ADDENDUM #02

CONTRA COSTA COMMUNITY COLLEGE DISTRICT

L-4030 Brentwood Solar PV & Resiliency Project
Brentwood Center

New PV Canopy Accessible Parking Improvements Criteria Document

Exhibit 1: Campus Site Plan
NOT-TO-SCALE

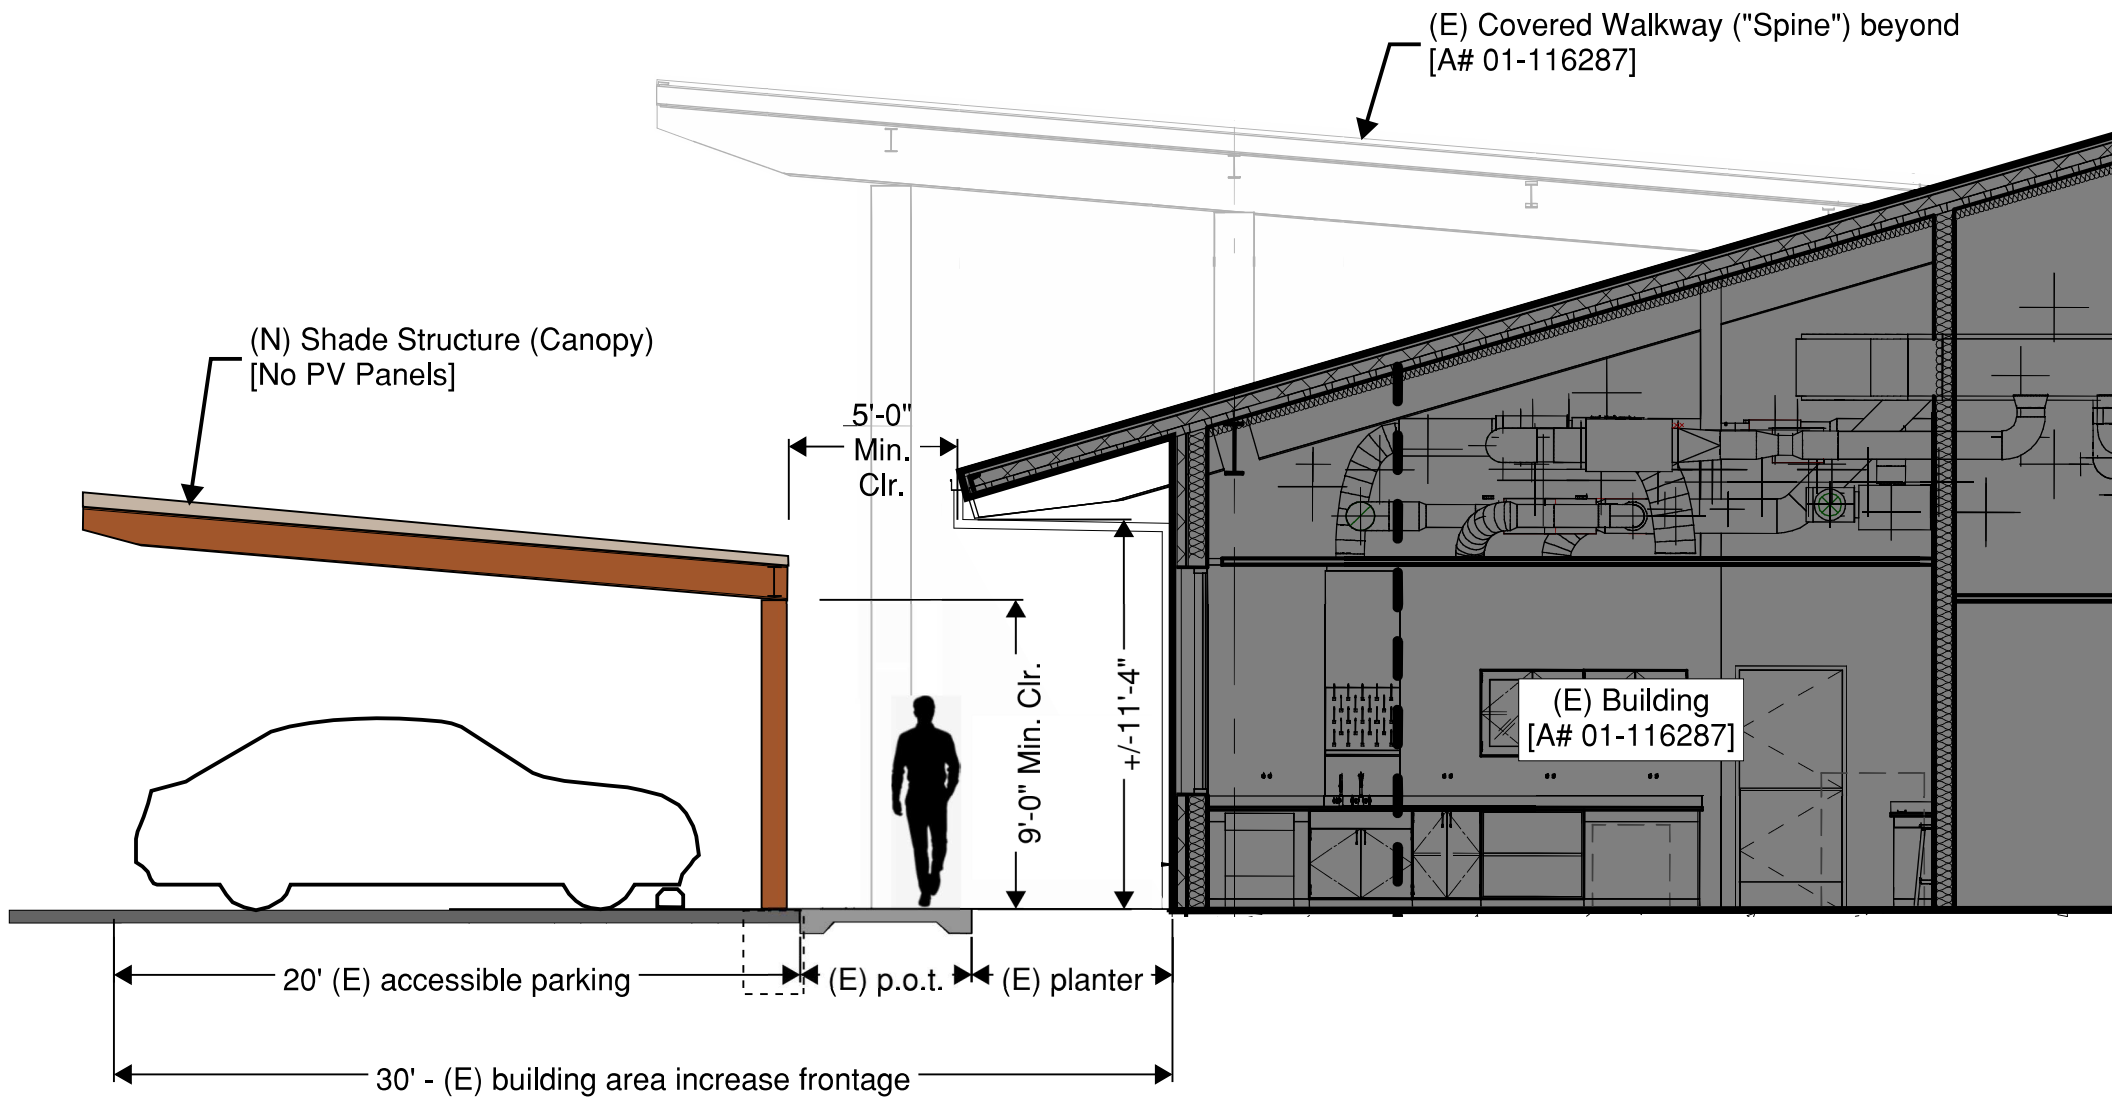
1. Add parking shade structure required to satisfy accessibility requirements and DSA. See attached bridging documents prepared by Ratcliff Architects .

1. New, free-standing shade structure (no PV panels), compliant with DSA IR 31-1, covering a minimum of five (5) existing accessible parking spaces for the designated number of standard parking spaces being shaded by the new solar PV canopies per 2022 CBC Table 11B-208.2 (refer to Exhibits 1, 2, and 3 for additional information).
